## ADDENDUM 1

PROJECT NAME: FIRE STATION #24 REPLACEMENT

DATE: 07/29/2020

RFCSP: #061720DR

**5 KITCHEN**  
SCALE: 1/4" = 1'-0"

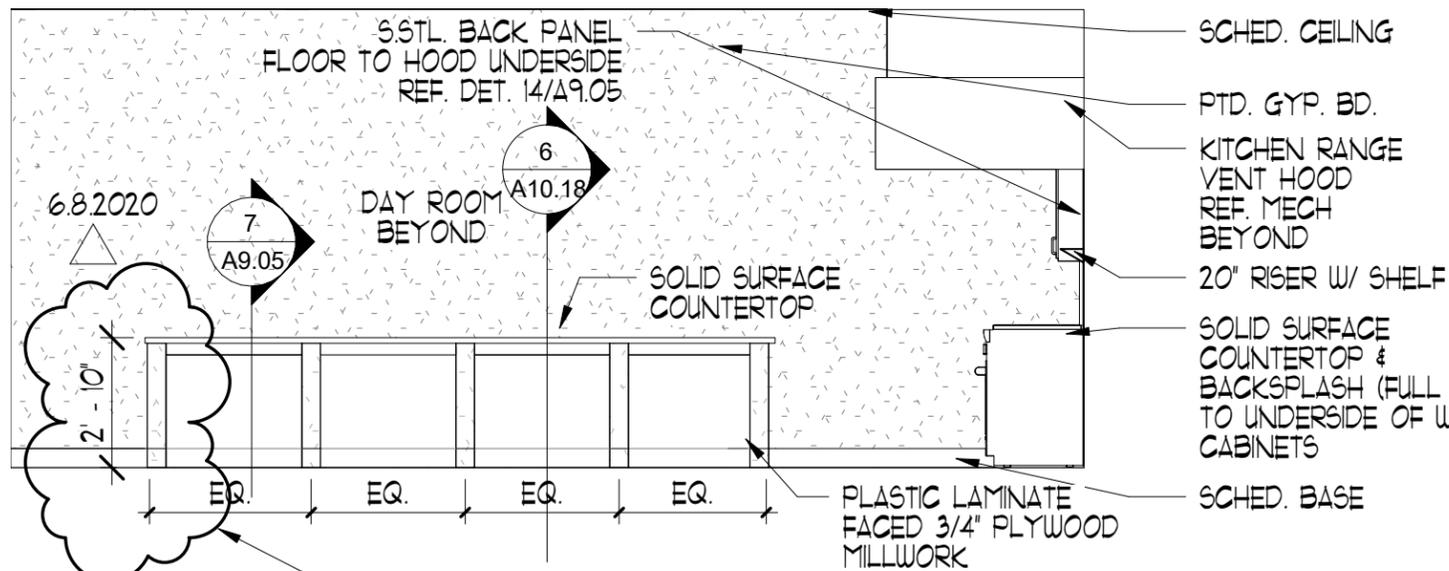
AMENDMENT # 6.8.2020 - REVISE COUNTER HEIGHT FROM 3'-0" TO 2'-10"

**1 PLUMBING FLOOR PLAN - SANITARY AND VENT**  
 P1.01 1/8" = 1'-0"

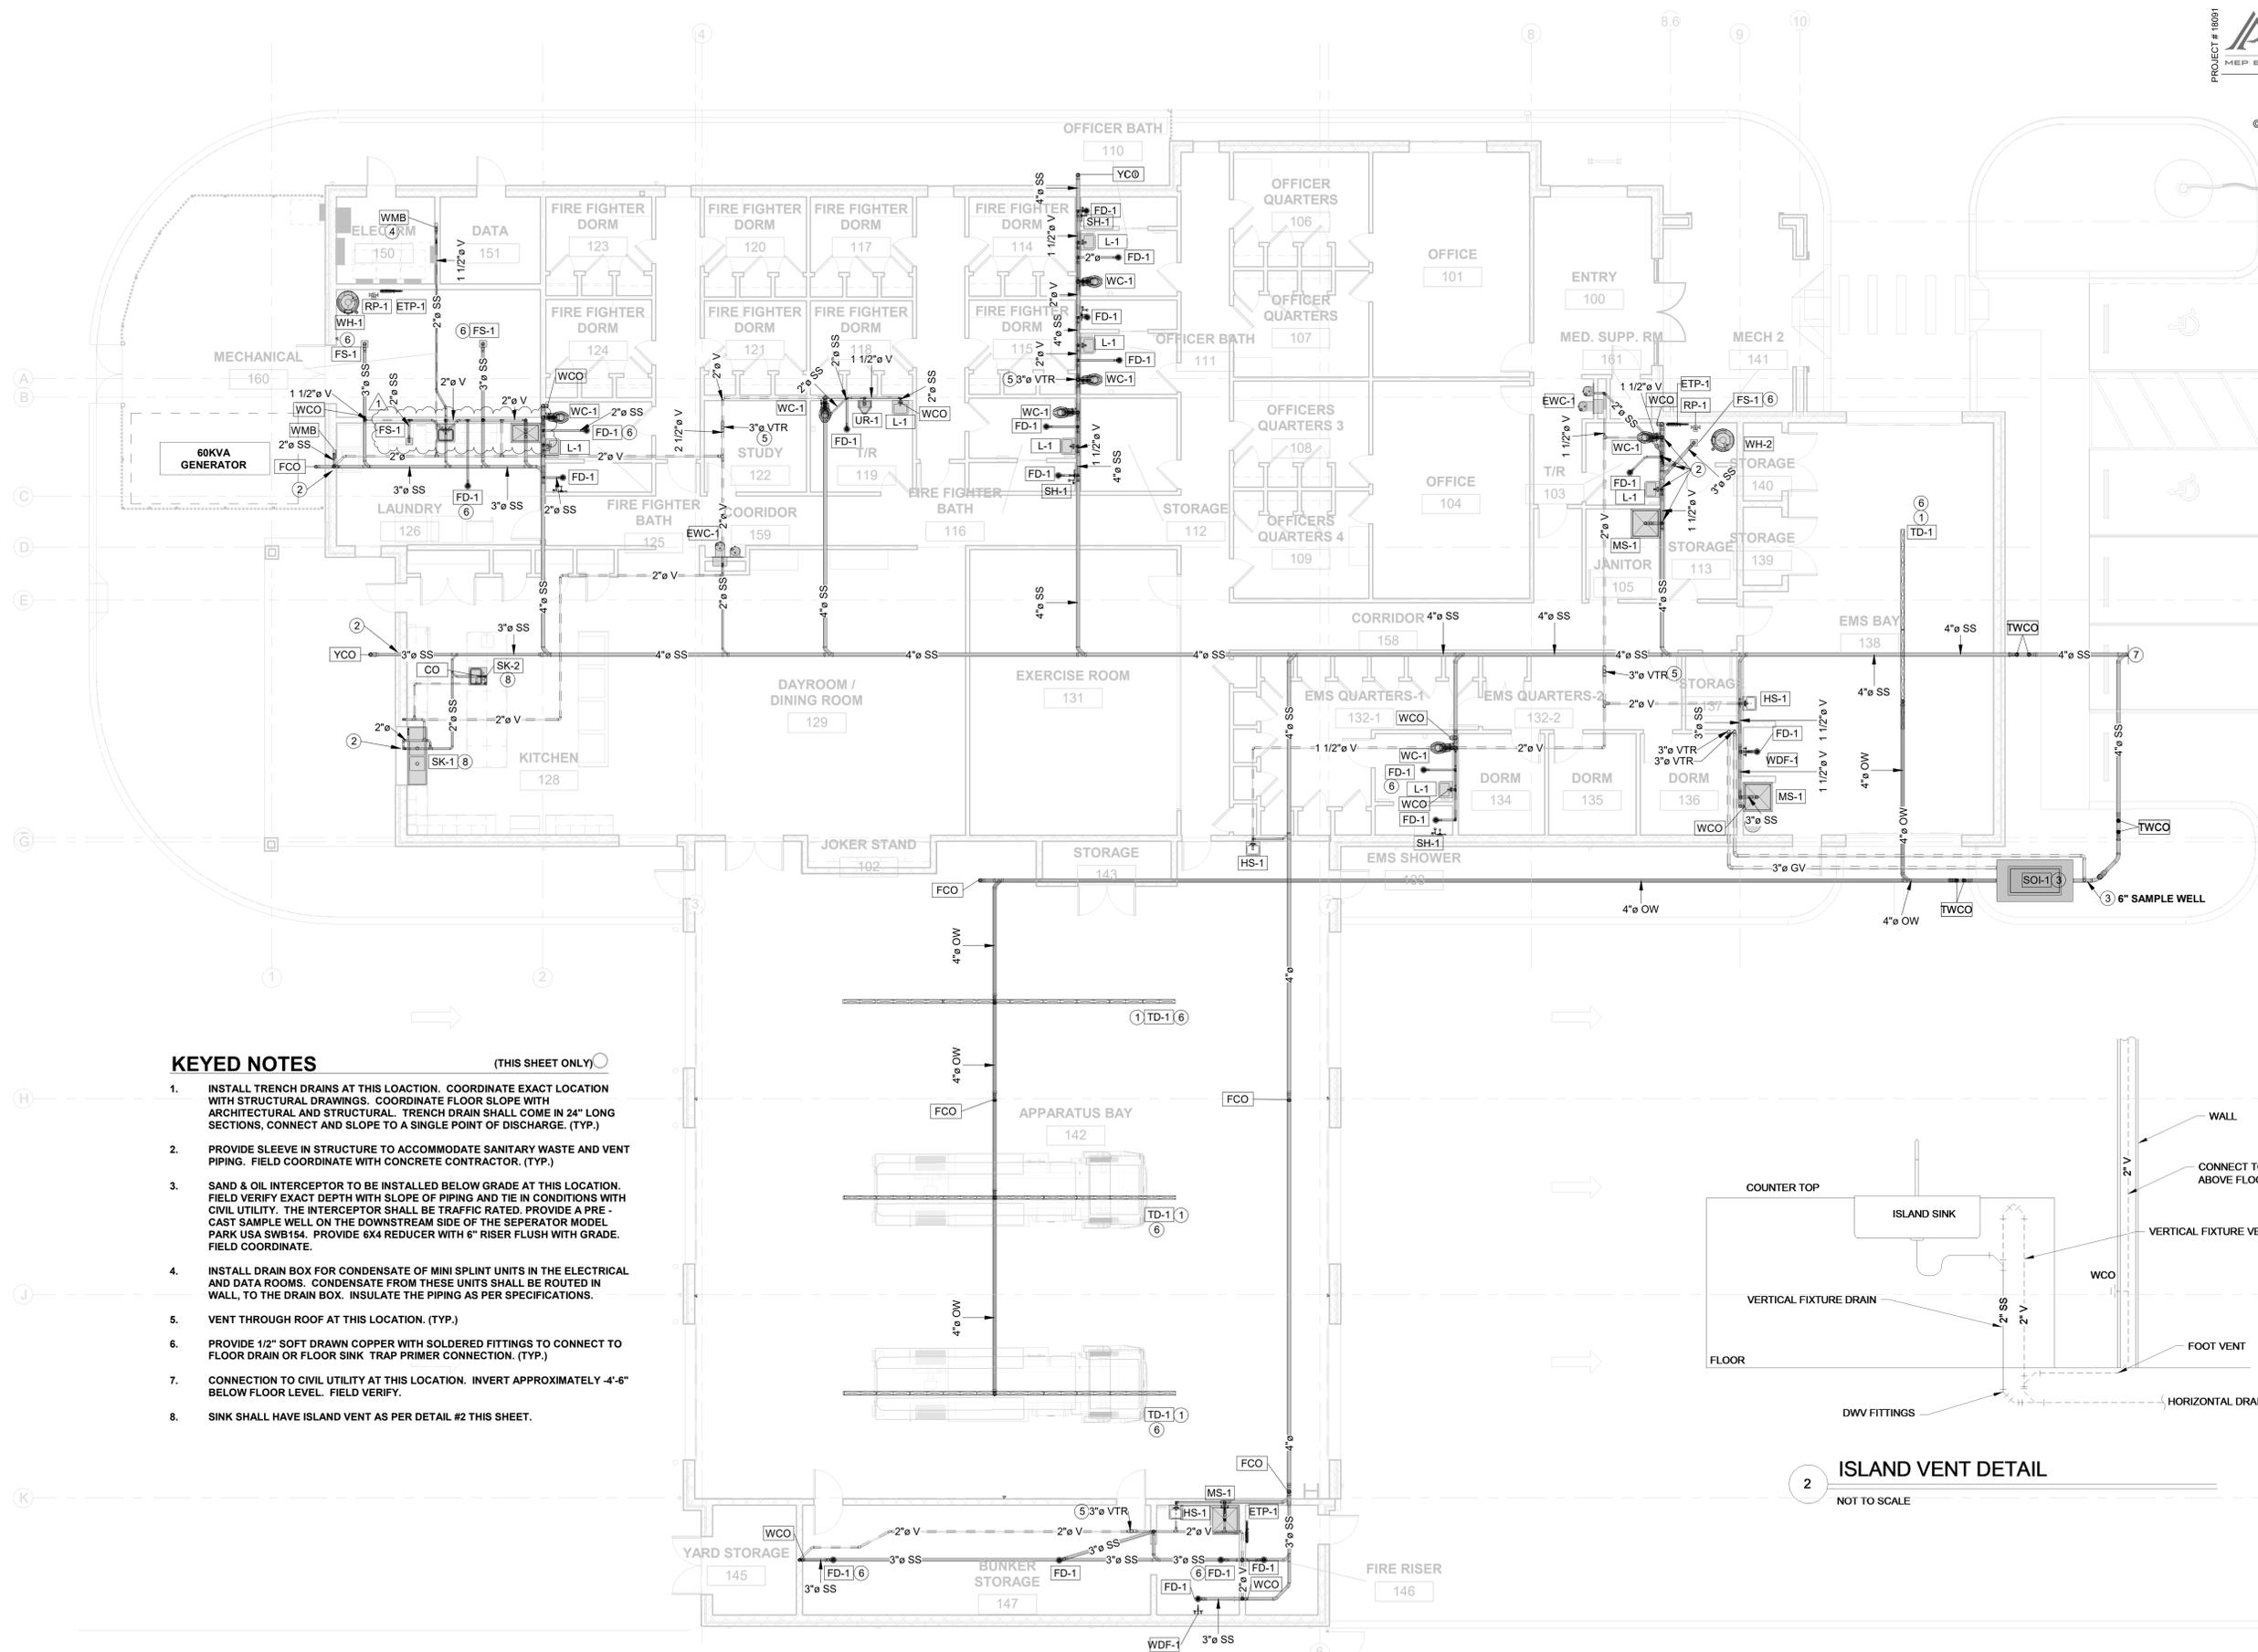
30. Sheet P1.01, Revise FS-1 location to coordinate with shifted ice maker per attached revised drawing.

**PLUMBING FLOOR PLAN - WATER AND GAS**  
 1 P1.02 1/8" = 1'-0"

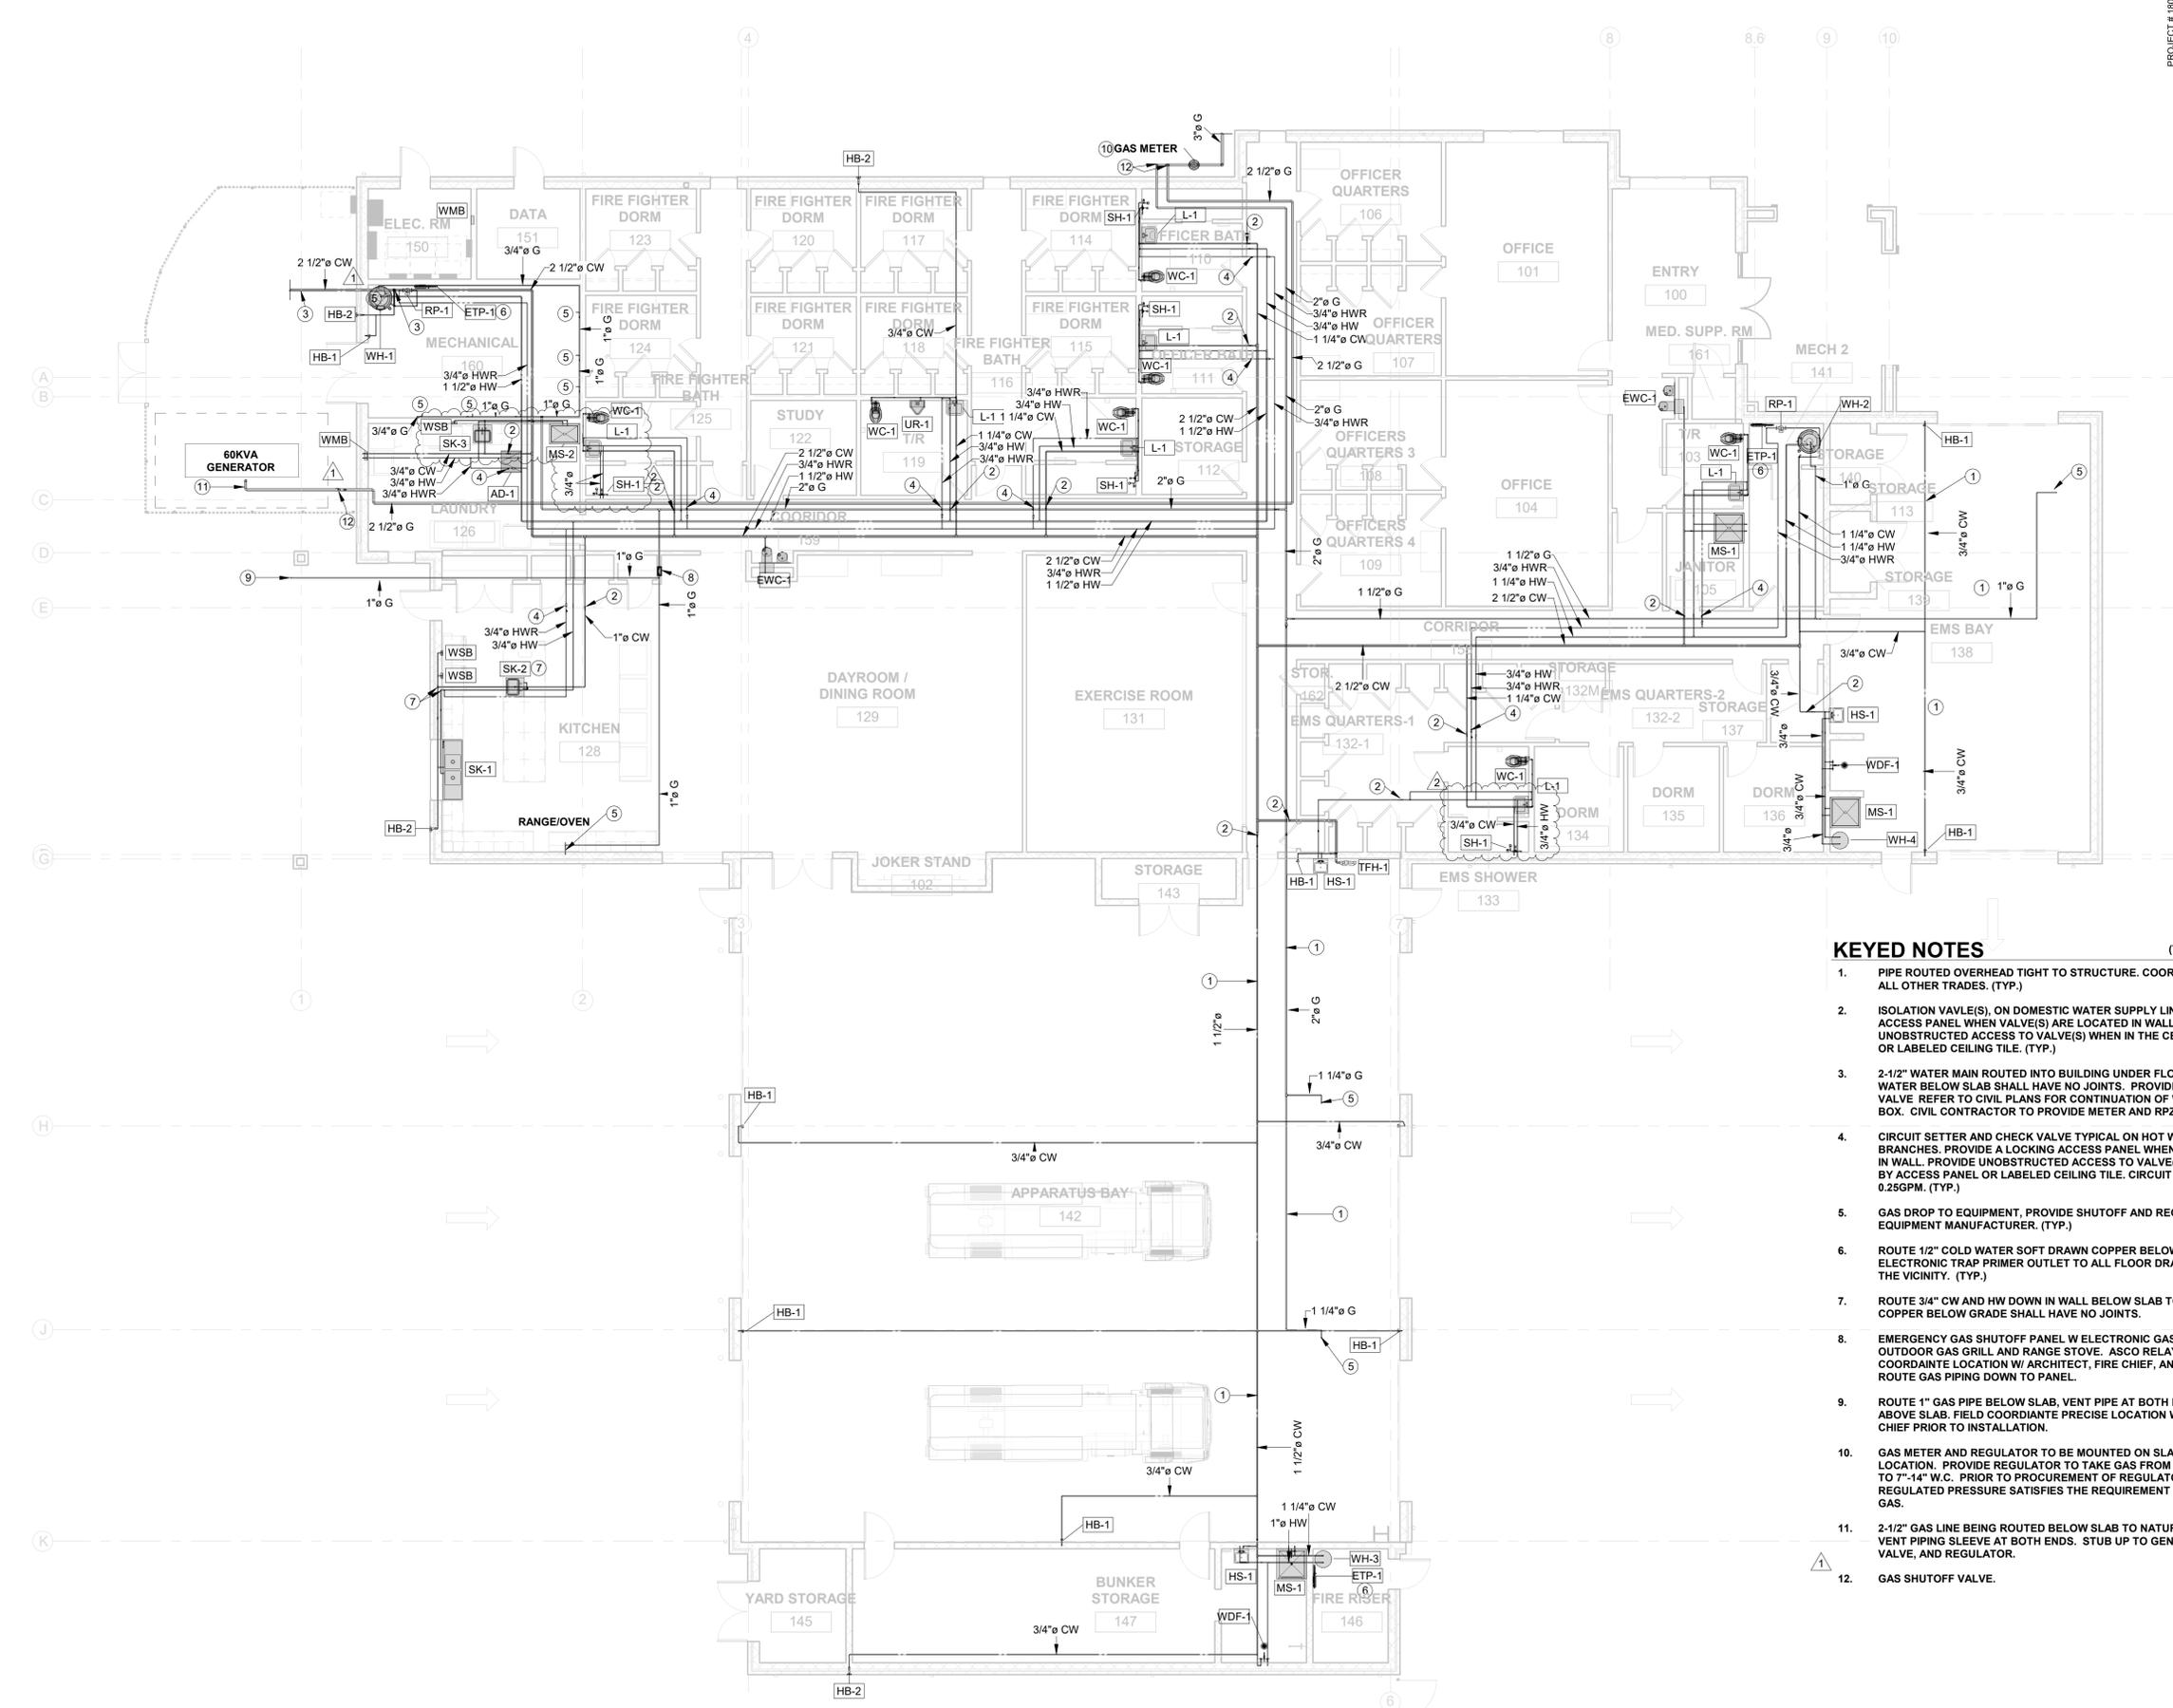
31. Sheet P1.02, Provide gas shut-off valve, revise SH-1 location in EMS Shower Room 133 and Fire Fighter Bath 125, and revise WSB location to coordinate with shifted ice maker. per revised Sheet P1.02 attached.
32. Sheet P2.02, Revise SH-1 location in EMS Shower Room 133 and Fire Fighter Bath 125.
- 33 Sheet P3.02, Revise Gas Riser Diagram. Add gas shut-off valve per revised sheet P3.02 attached.

1 US DIGITAL DESIGNS REFERENCE  
 T5.02 SCALE: NOT TO SCALE

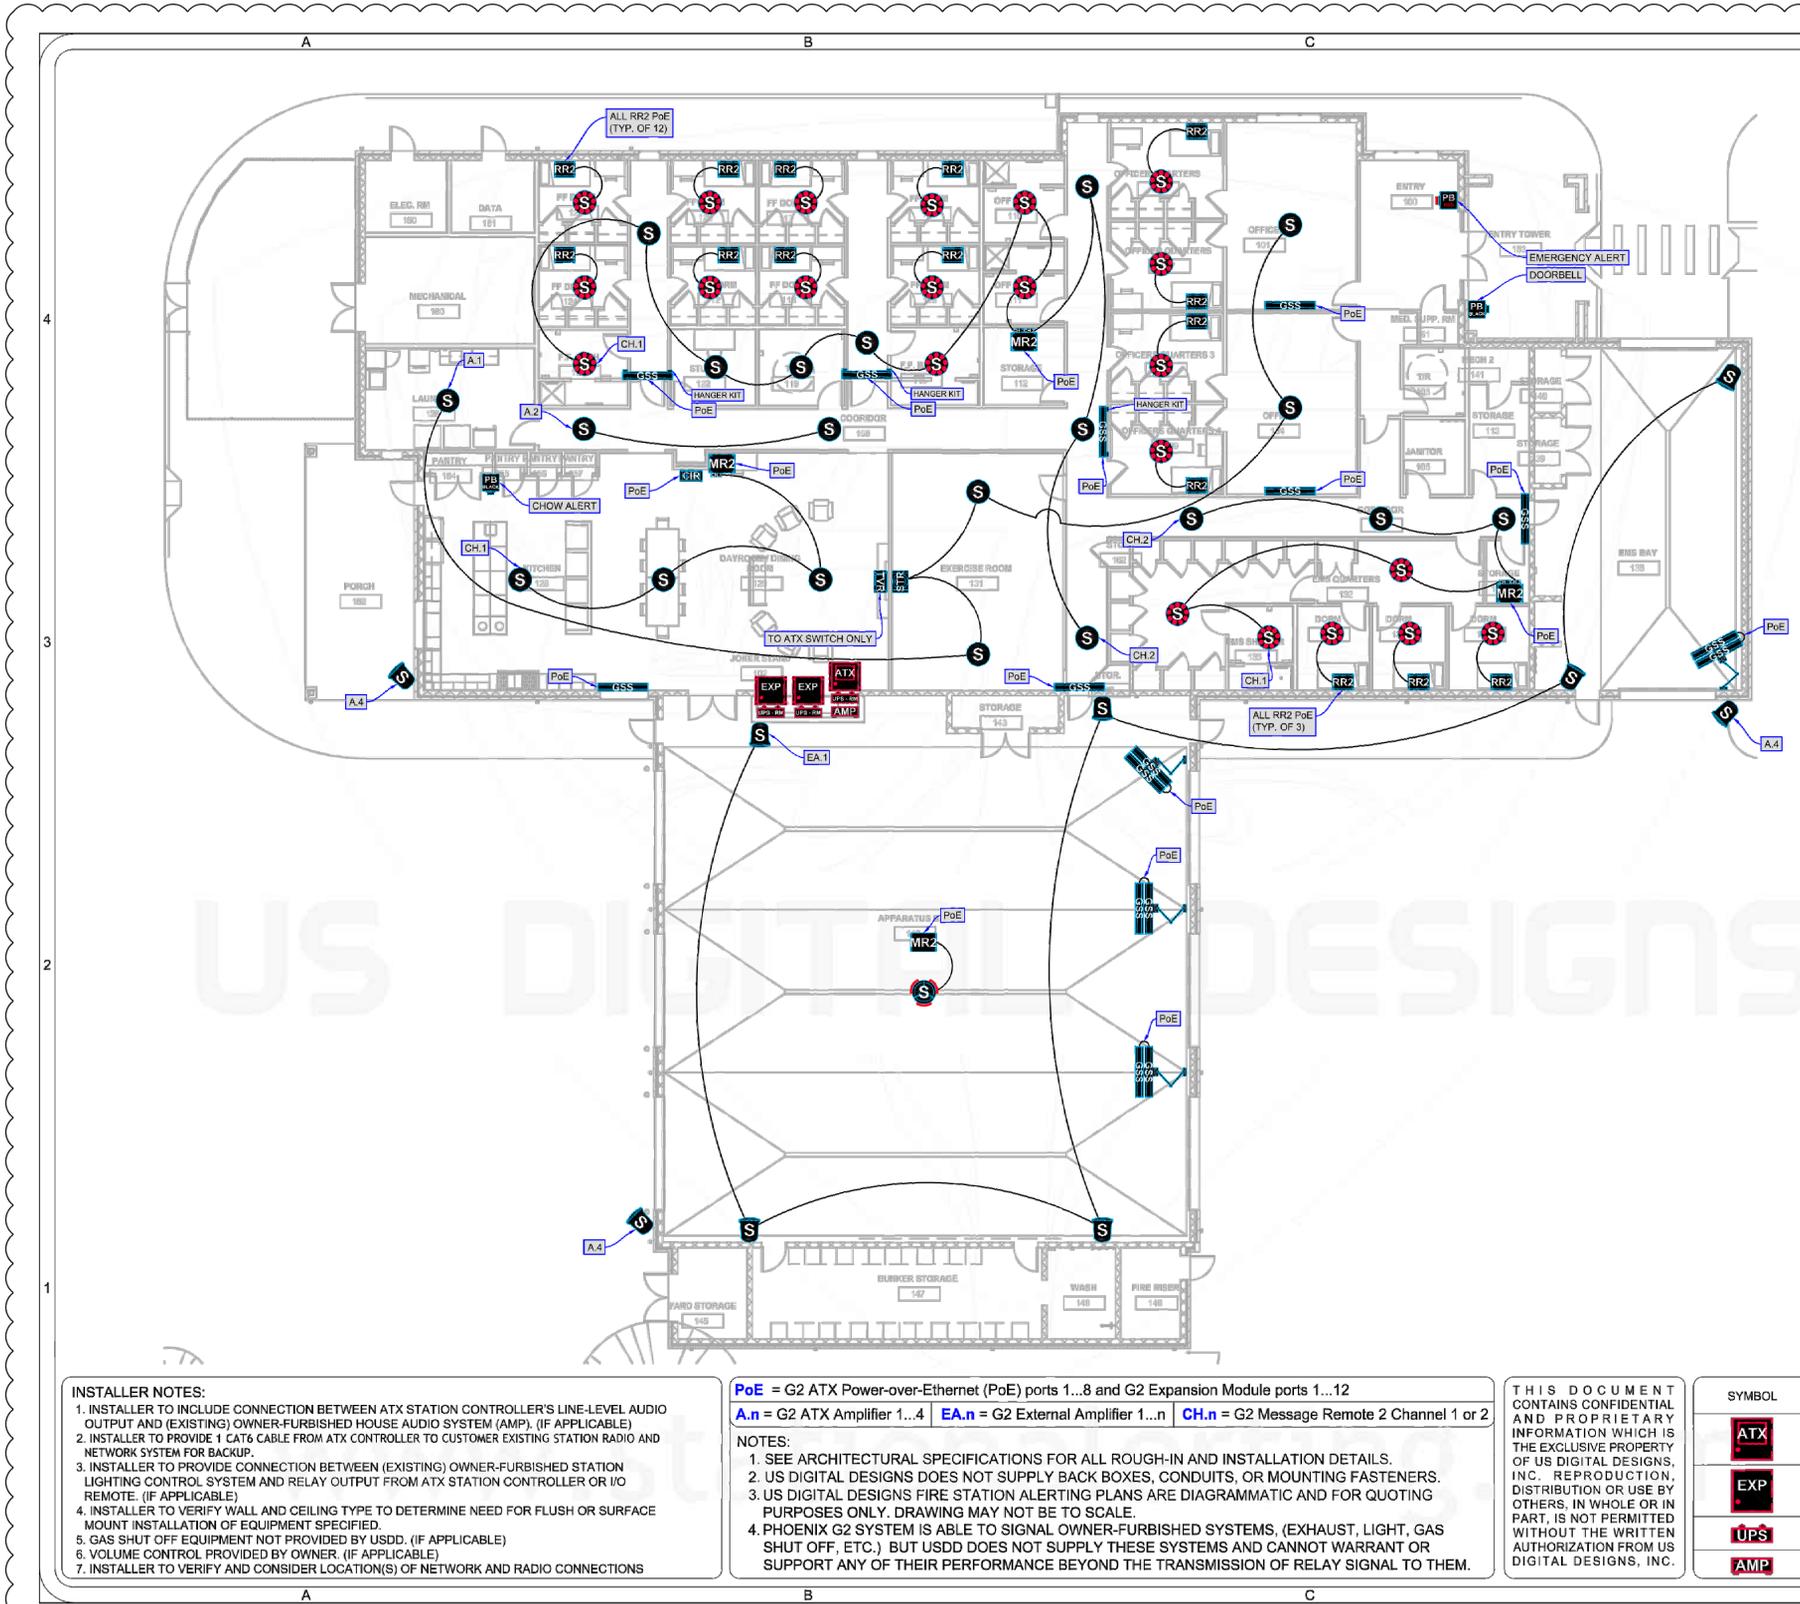
34. Sheet T3.02, Revise drawing per the attached Sheet T3.02:  
Special Systems Floor Plan, Symbol MR, has been revised to MR2.  
Room 137, MR2 relocated from plan north wall to plan south center wall.  
Room 112, MR2 relocated to plan north center wall.  
Room 129, Add MR2 to plan north wall.  
Room 129, Relocated CIR as indicated on the drawing.  
Deleted ceiling speaker.
35. Sheet T5.02, Revise drawing per the attached Sheet T5.02: Floor Special Systems Plan Detail, US Digital Designs drawing revised as noted.
